Product / Process Change Notification (PCN)	
<input checked="" type="checkbox"/> Major change <input type="checkbox"/> Minor change	
PCN #: PCN_WS-TASV_20220501 Affected Series: 430783034816 ; 430773034825 430783051816 ; 430773051825 PCN Date: April 01, 2022 Effective Date: May 01, 2022	Change Category: <input type="checkbox"/> Equipment / Location <input type="checkbox"/> General Data <input type="checkbox"/> Material <input type="checkbox"/> Process <input checked="" type="checkbox"/> Product Design <input type="checkbox"/> Shipping / Packaging <input type="checkbox"/> Supplier <input type="checkbox"/> Software
Contact: Product Management Phone: +49 (0) 7942 - 945 5001 Fax: +49 (0) 7942 - 945 5179 E-Mail: pcn.eican@we-online.com	Data Sheet Change: <input type="checkbox"/> Yes <input checked="" type="checkbox"/> No Attachment: <input type="checkbox"/> Yes <input checked="" type="checkbox"/> No

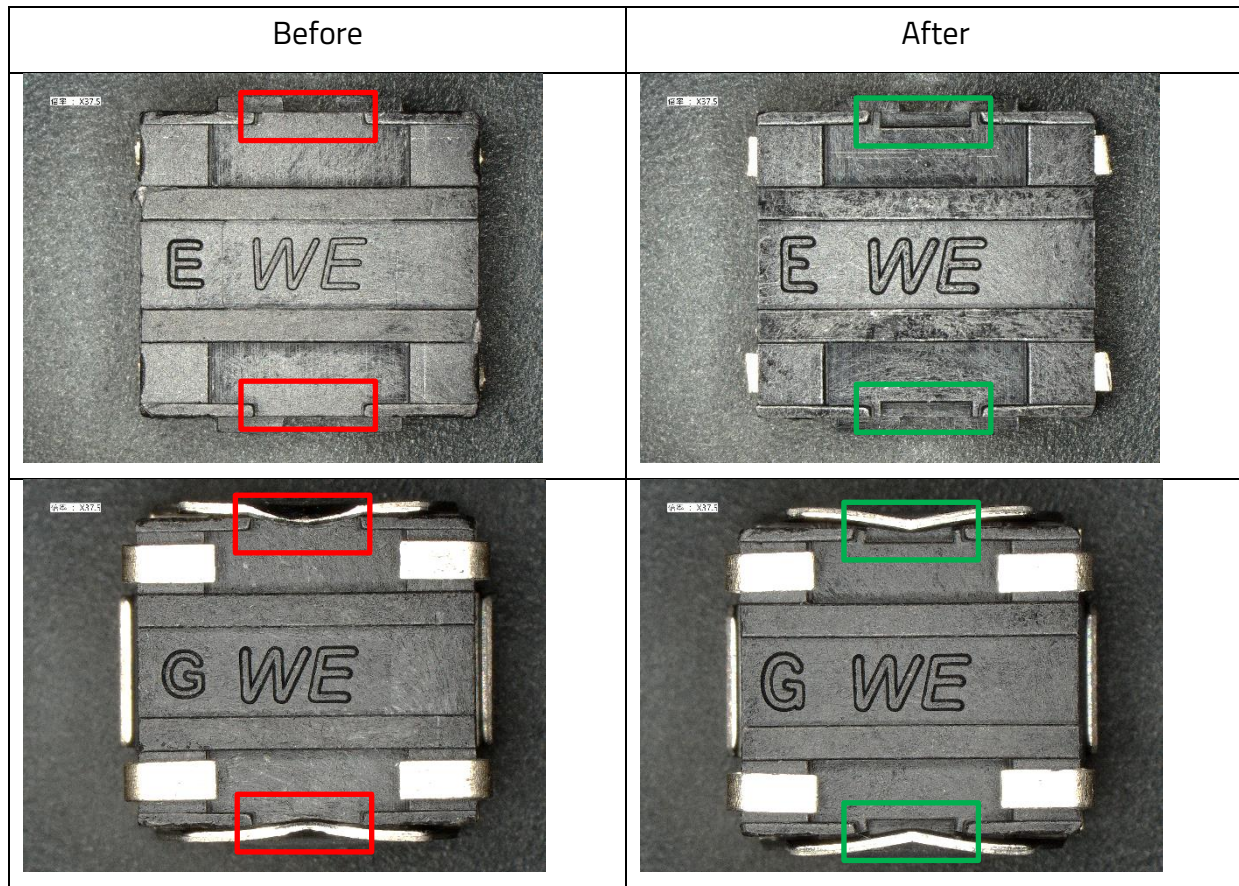
Description and purpose of change: <p>In order to enhance the product reliability, Würth Elektronik will change the mold of frame for WS-TASV 4307x30xx8xx series.</p> <p>All products with date code 2022-04-25 or later, will be affected by this change.</p> <p>There will be no change in function, quality or reliability of the product.</p>

Frame mold : the bottom shape, the middle of two sides
